ORIGINATION FORM

Proposed Revisions to a Standard Plans Index
(Please provide all information — Incomplete forms will be returned)

Index Number: 711-003

Index Title: Interchange Markings

SINGLE LANE RAMPS - ENTRANCE TERMINALS

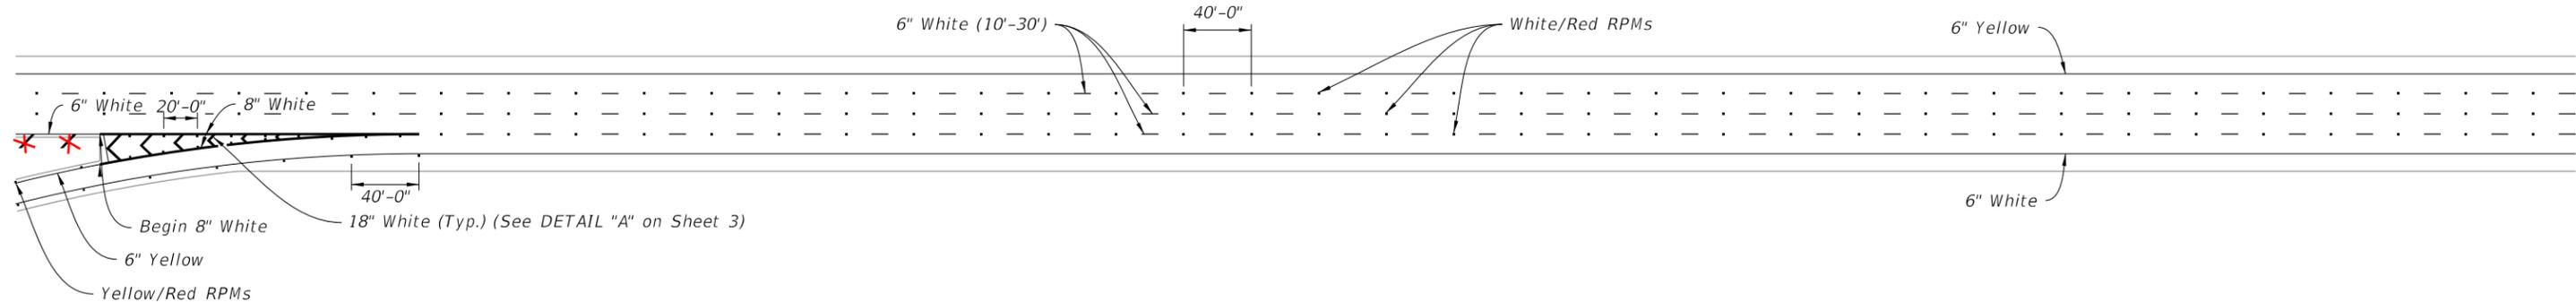
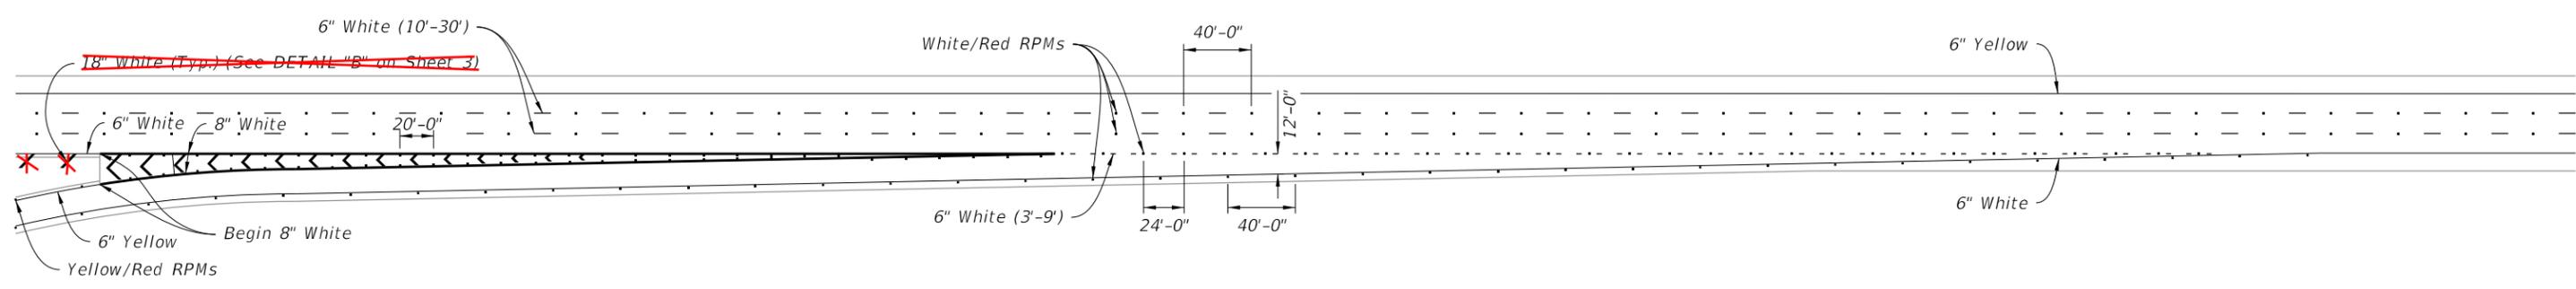
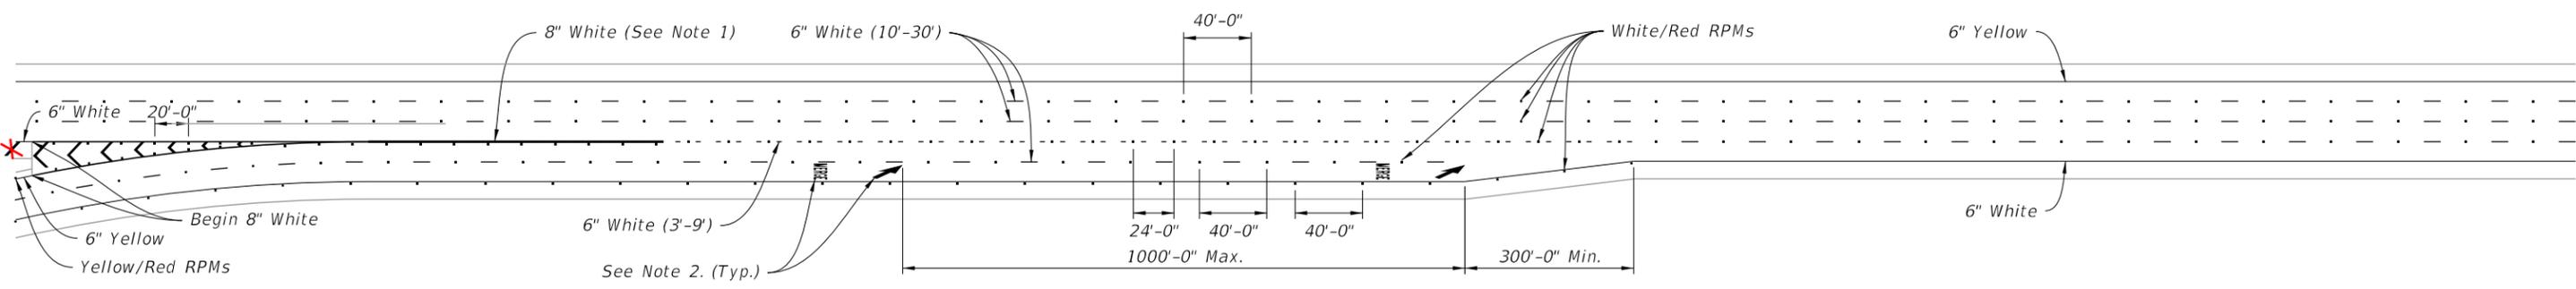
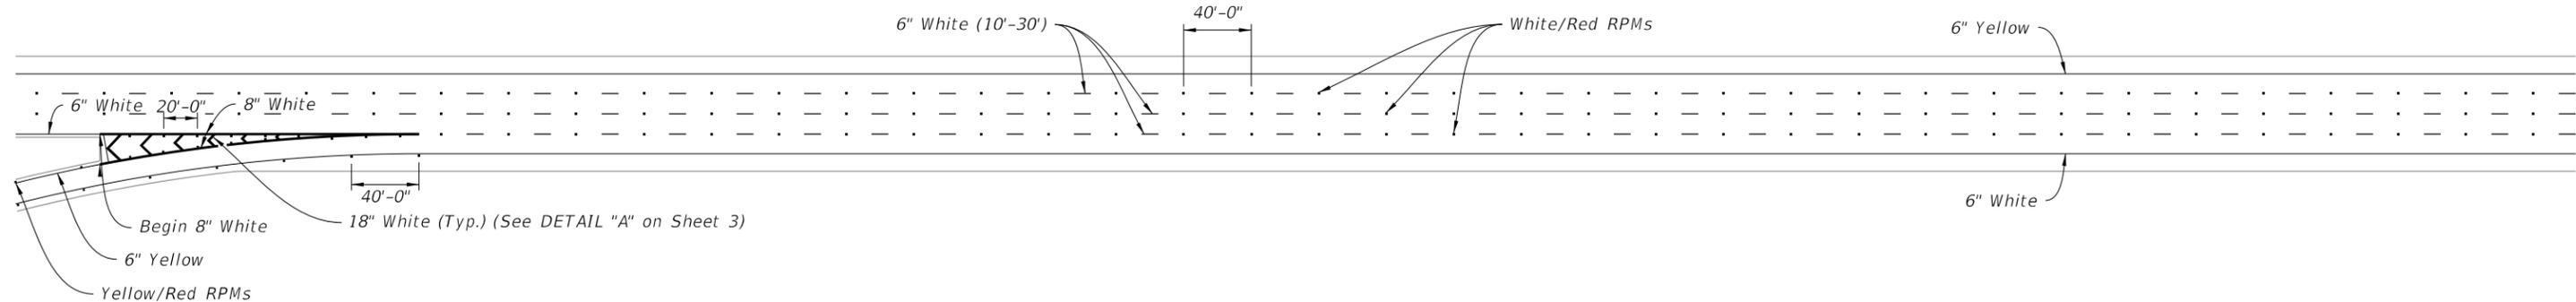
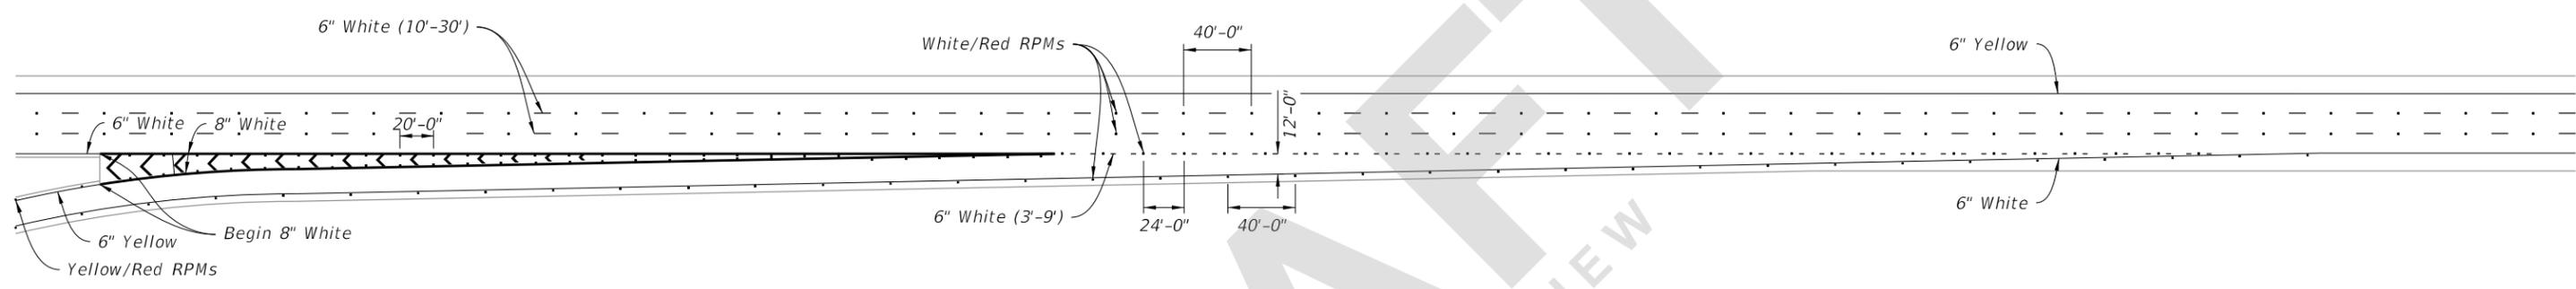
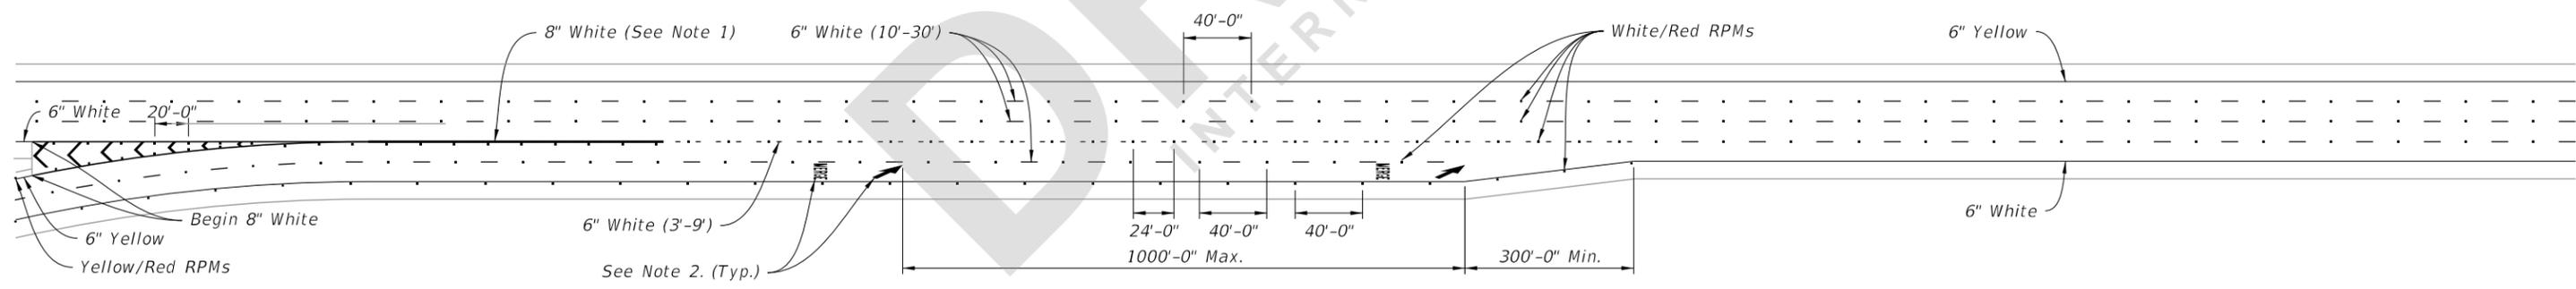
Sheet 1: Deleted the 18" white hash marks

18" diagonal markings on entrance ramps were deleted because they were not required by the AASHTO Greenbook

TYPICAL PAVEMENT MARKINGS AT ENTRANCE RAMPS

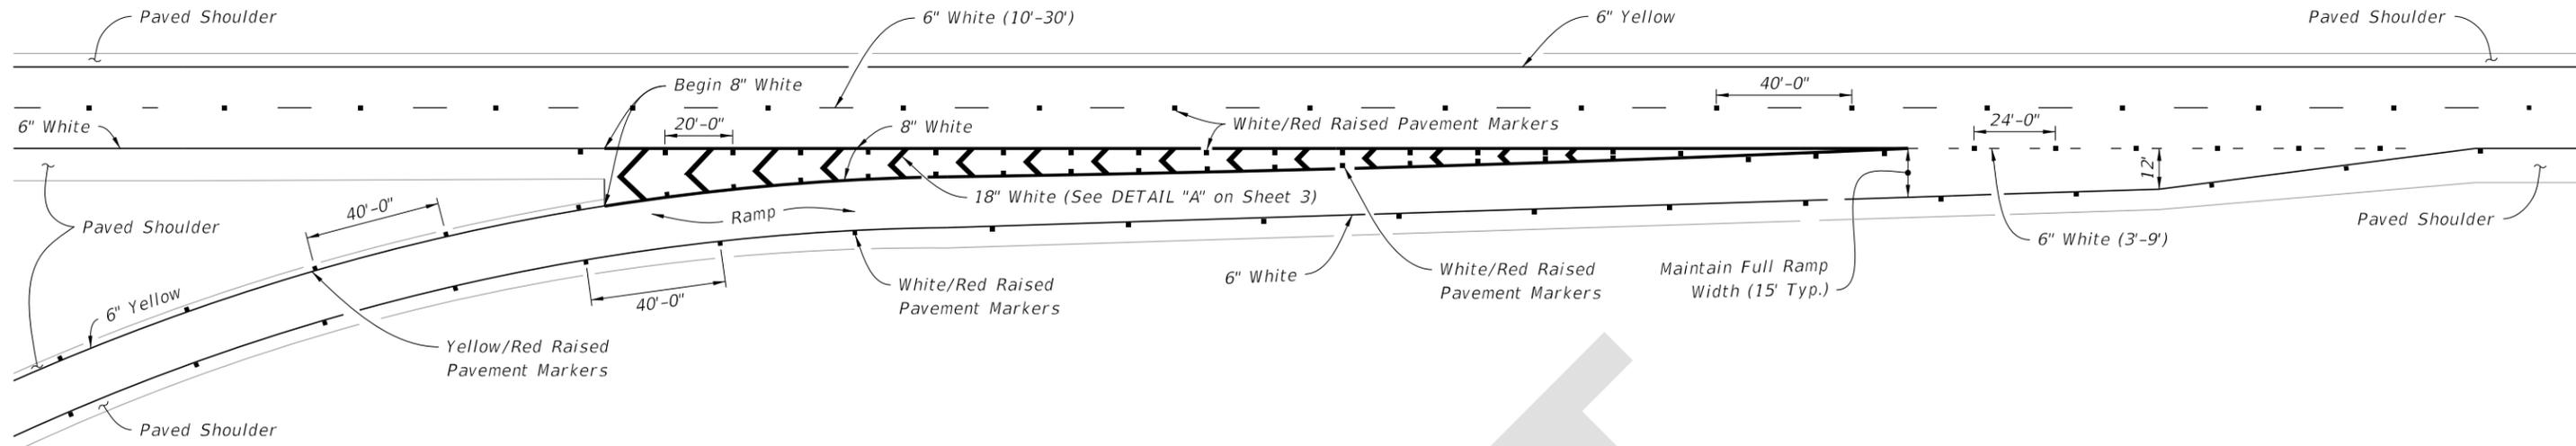
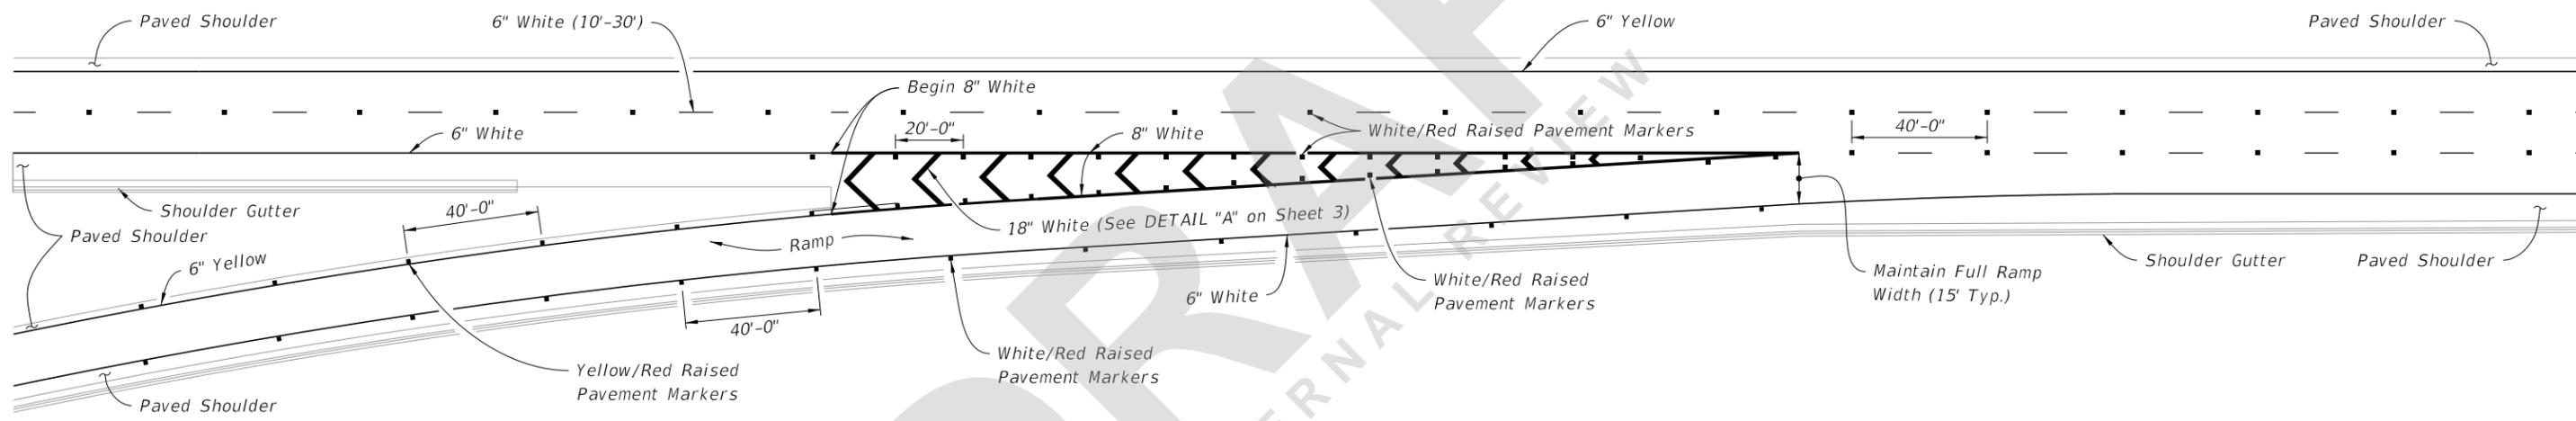
Sheet 2: Deleted the 18" white hash marks
